**Re: Rapiscan AIT System Radiation Survey Reporting**

**Secure 1000 Radiation Emission Measurement**

## R-0646-1 Addendum (Documentation Errors)

Product Name	Secure 1000SP (Single Pose)
Serial Number	<b>S51024008</b>
Radiation Emission Measurement	Radiation Survey Dated: 12/01/2010
RSO Initials	[REDACTED]

3. Inspection Zone Boundary Radiation Measurement; Survey Table. 3

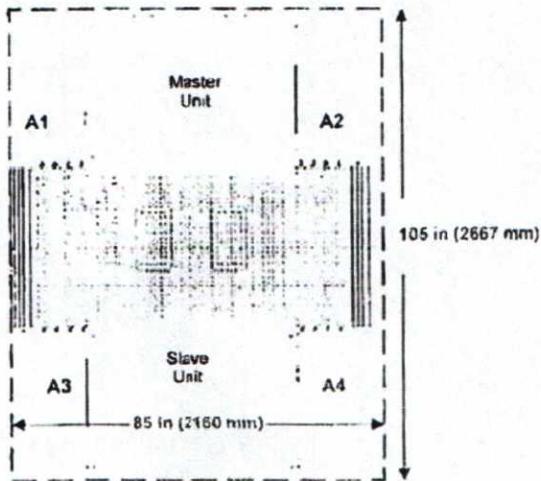
not divided by 10

1.8  
1.8

1. TABLE 3: Incorrect presentation of data in Column 3 for Measured Exposure. Indicated value is .5 and .1 uRem. The correct value should be 1 uRem.
2. TABLE 3: Incorrect presentation of data in Column 6 for Dose Equivalent. Indicated value is .18 uRem. The correct value should be 1.8 uRem. RSO corrected the result.
3. Technician did not print his name on survey report.

The service technician should attend refresher training.

The corrected data indicates this system was operating within expected parameters. No re-survey is required for this system.
